PROJECT: ADDENDUM NO.: 1

Willow Lake School Addition

OWNER: DATE OF ISSUANCE: Willow Lake School District 12-3 February 10, 2023

CO-OP Architecture

FIRST FLOOR PLAN - AREA C - ALTERNATE 2 1/8" = 1'-0"

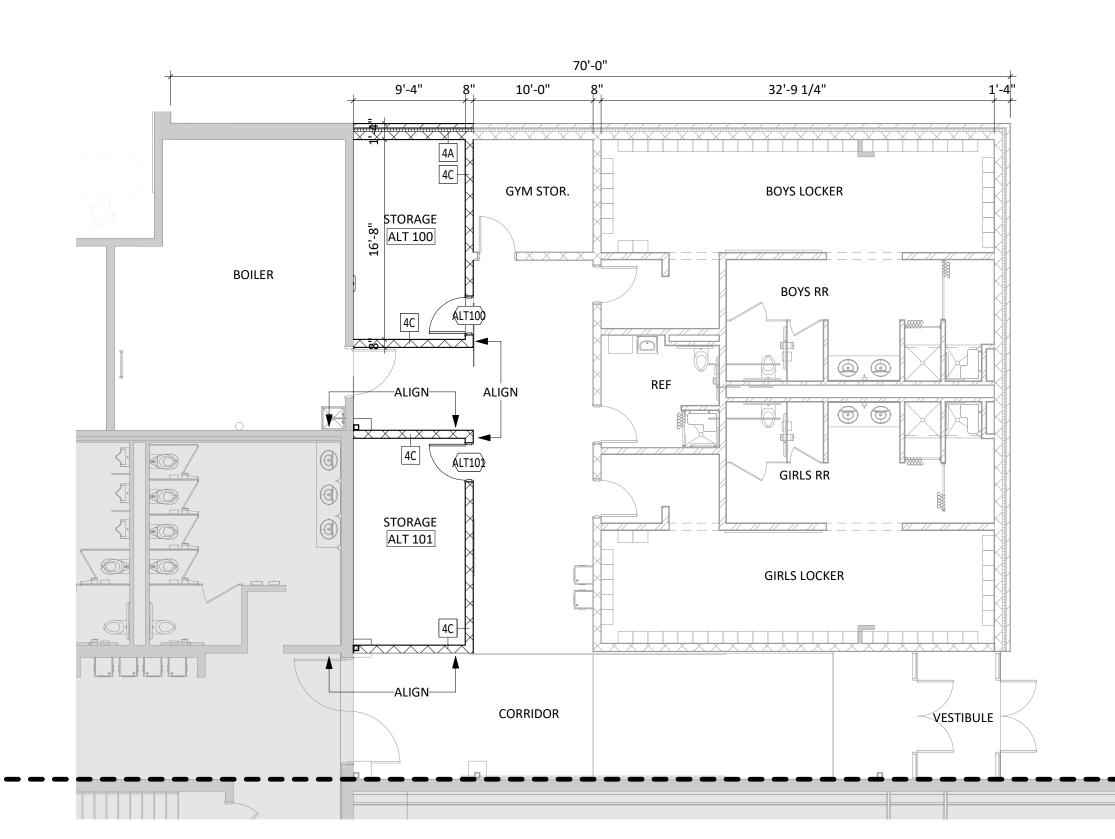
- 36) Sheet A611 GLAZING DETAILS
 - a. Removed general notes legend.
- 37) Sheet A991 ALTERNATE
 - a. Revised name of plan to be Alternate 2.
